ALAMEDA COUNTY COMMUNITY DEVELOPMENT AGENCY  
PLANNING DEPARTMENT

STAFF REPORT

**APPLICATION:** PLN2021-00044

**PROPOSAL:** **MODIFICATIONS TO PREVIOUS APPROVAL FOR VESTING TENTATIVE TRACT MAP SUBDIVISION (TR-8607) AND SITE DEVELOPMENT REVIEW**, to allow revision to a new mixed-use multi-family project with 138 (previously 163) rental housing units, 11,049 (previously 11,524) sq. ft. of indoor retail, 983 (previously 660) sq. ft. of outdoor retail seating area, no proposed realignment of Via Mercado.

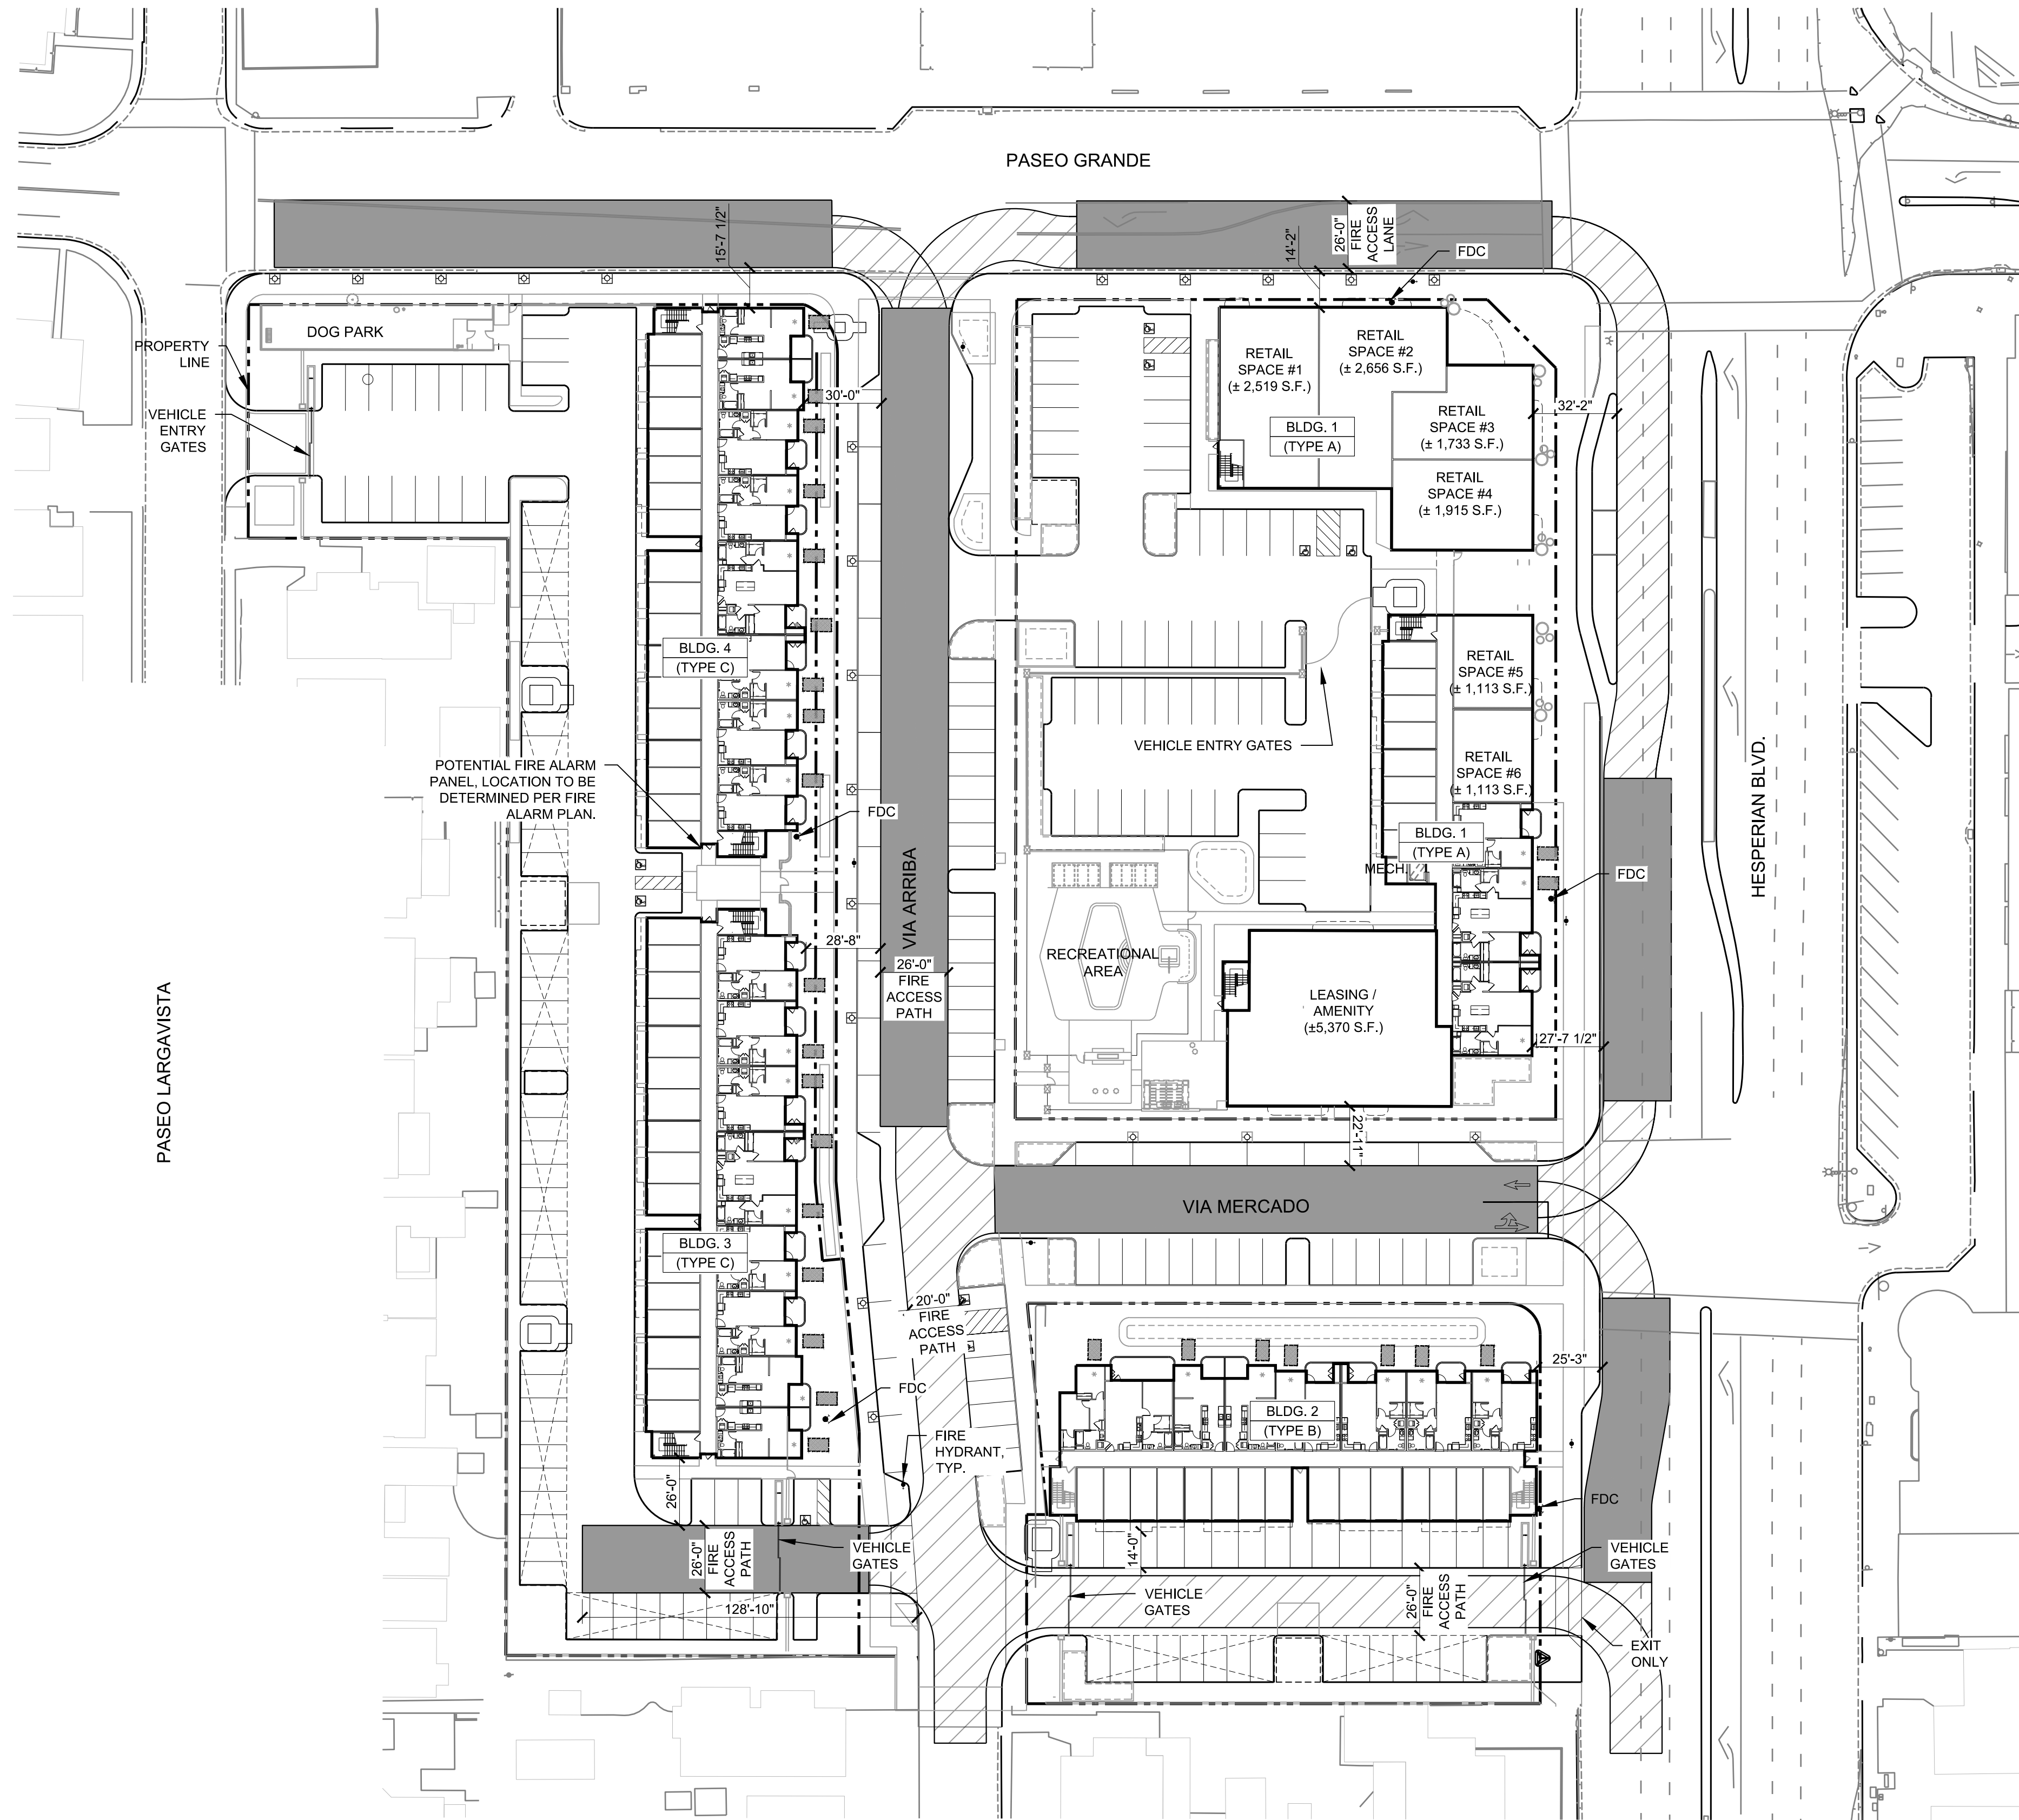
4	Some FDCs shown on sheet A1.1 are in locations not located along a fire access roadway. Please revise.	See FDC locations on Civil drawings and the fire master plan, sheet A1.1
5	The plans do not show the location of current hydrants or proposed hydrant locations. Please show the location of all hydrants and indicate if new or existing.	See hydrant locations on Civil utility drawings C4.0 and C4.1 and the fire master plan, sheet A1.1
6	Sheet G0.0 under deferred submittals. There is a reference to fire pump and fire pump rooms if necessary. The need for fire pump rooms should be determined at this time given the amount of space, large doors, fdc location, hydrant proximity and required direct access to fire access roads.	Per the Hydraulic Demand Assessment completed by Commercial Fire Protection, fire pump rooms are not required for this site. Reductions in building height have allowed the project to proceed without fire pumps. Comment noted for follow-up and reclarification during permitting phase.
